N1996A-01

S E R V I C E N O T E

Agilent CSA Spectrum Analyzer, N1996A

Residual Responses due to Shield Problem on A4 Digital IF Assembly

Figure 3. Check that there is no gap longer than 4mm between shield wall and pc board footprint.

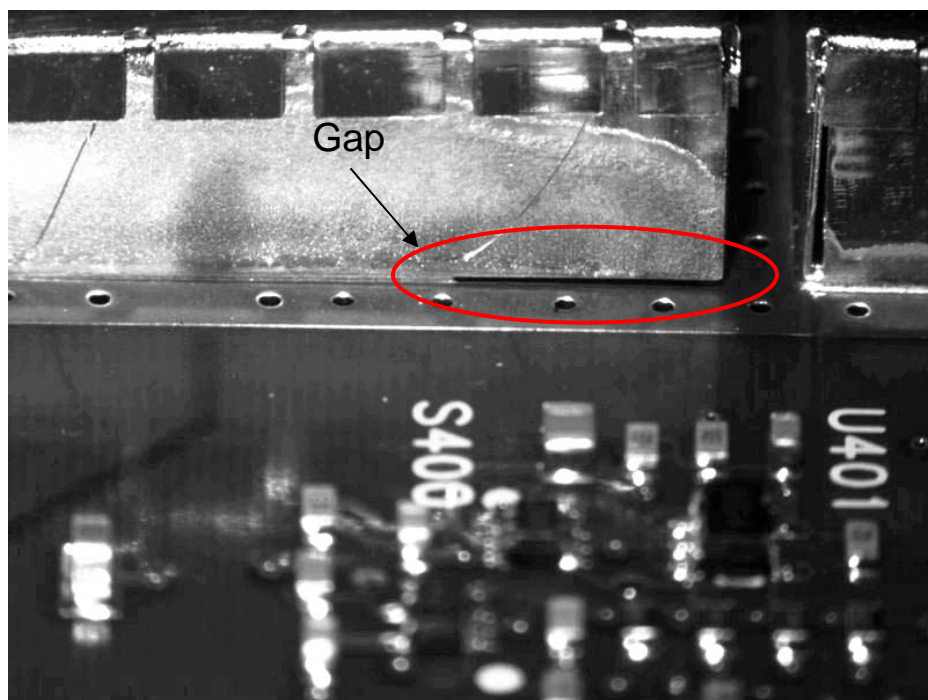
5. Inspect the shield frames using an eye loupe or magnifying lens. Ensure that the shield frames meet the following criteria:
 - a. Ideally, there should be a continuous fillet of solder along the outside and inside edges where the shield frame walls meet the pc board. If there is any gap in the solder fillet greater than 4 mm, re-solder to fill the gap. Refer to Figures 3 and 6. When soldering the edges of the shield walls, be careful not to accidentally touch any pc board components with the soldering iron.

Figure 6. Correctly-soldered shield wall. Note that there is no excess solder wicked across the wall and the lid fingers rest uniformly on the shield

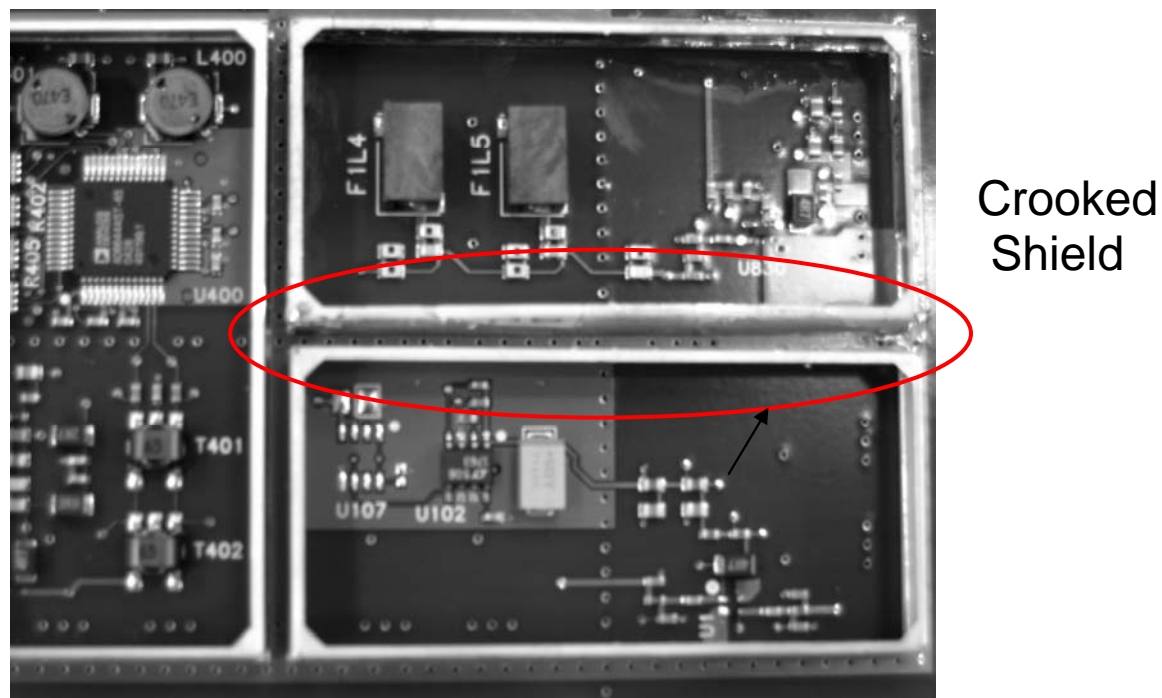
- b. Check that excess solder has not wicked up the side of the shield walls. Refer to Figure 4. The uneven surface created does not allow the shield lids to make good contact.

- c. Check that the shield frame walls align properly with the pc board footprint. Refer to Figure 5. If possible, re-solder the shield frame walls so that they are properly aligned. If this is not possible, replace the A4 DIF board with a new assembly.
